Text Contribution to P802.1Qdq

16 September 2022

- Propose to change clause X4.1 of P802.1Qdq/D0.1 as the following slides:

Problem

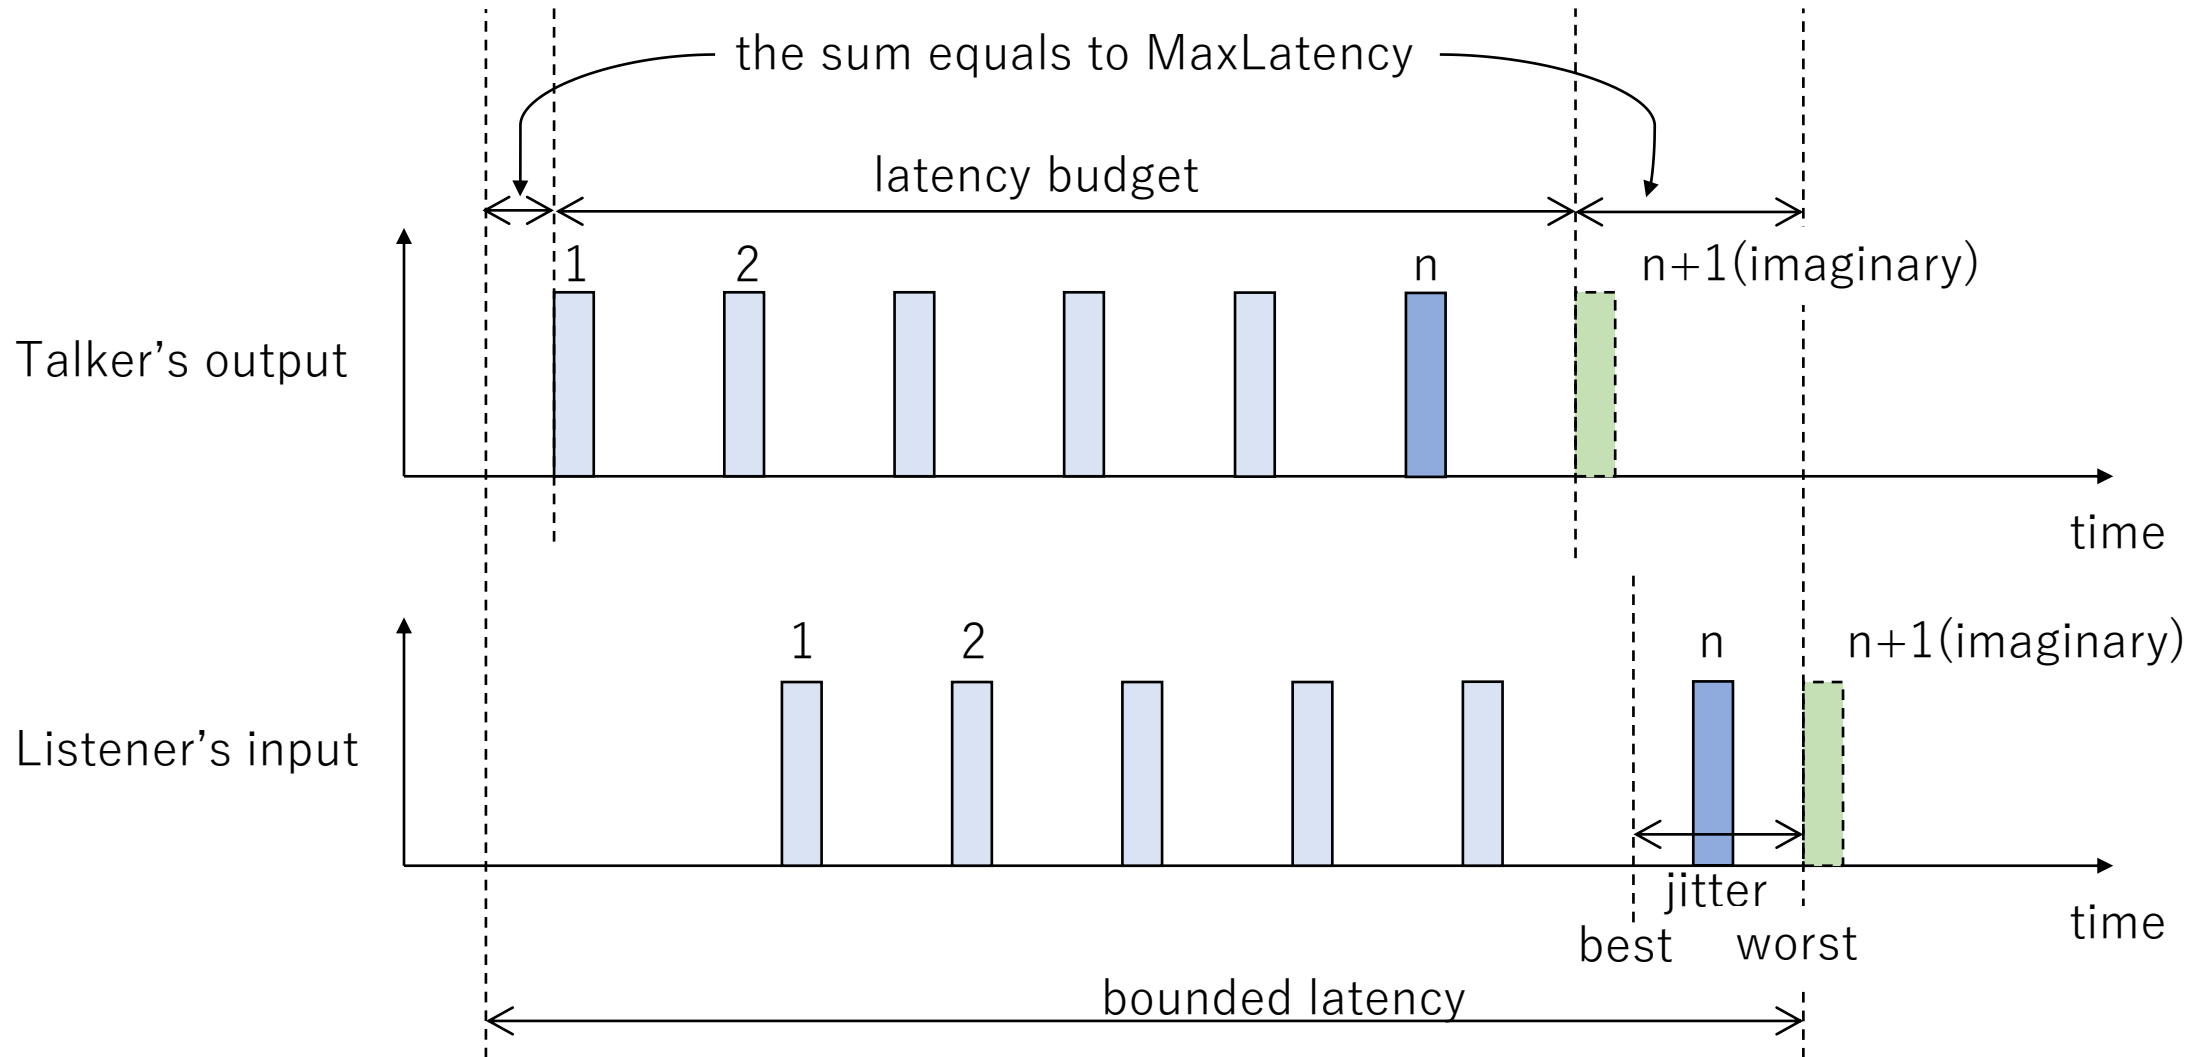
- An application developer may request to assure bounded latency including the last bit of the last frame of Blockdata. However, the current draft does not consider the remaining data after reference point of the last frame.

- Assuming that there is an $(n+1)$ th frame and calculating shaping rate with reference point of the $(n+1)$ th frame, the arrival of the first bit of the first frame through the last bit of n th frame is guaranteed within bounded latency.

* $(n+1)$ th frame = next frame of the last frame
